REMARKS

AMENDMENTS TO THE DRAWINGS:

FIG. 5

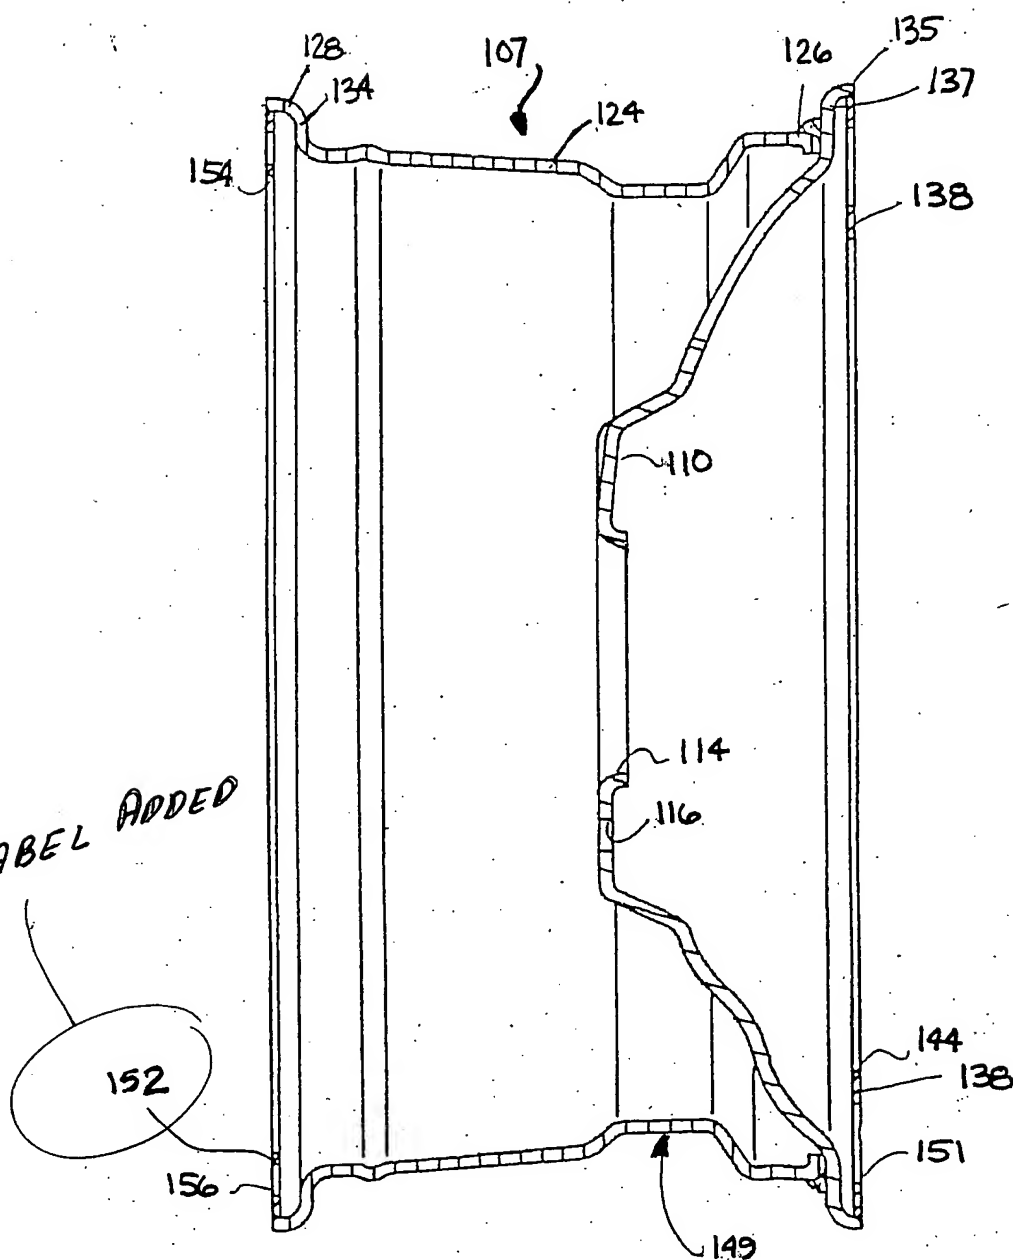
In the Office Action, the drawings stand objected to for not including reference character 152, found in the specification.

In the Office Action, the specification stands objected to since reference character 154 in Fig. 5 is allegedly not described in the specification.

LABEL ADDED

With regard to the drawings, Applicant hereby proposes labeling Fig. 5 to include the reference character 152 for the inboard reinforcing ring. Accordingly, Applicant respectfully requests withdrawal of the objection to the drawings.

The attached drawing sheets include changes to Fig. 5, wherein Fig. 5 has been labeled to include the reference character 152 for the inboard reinforcing ring.
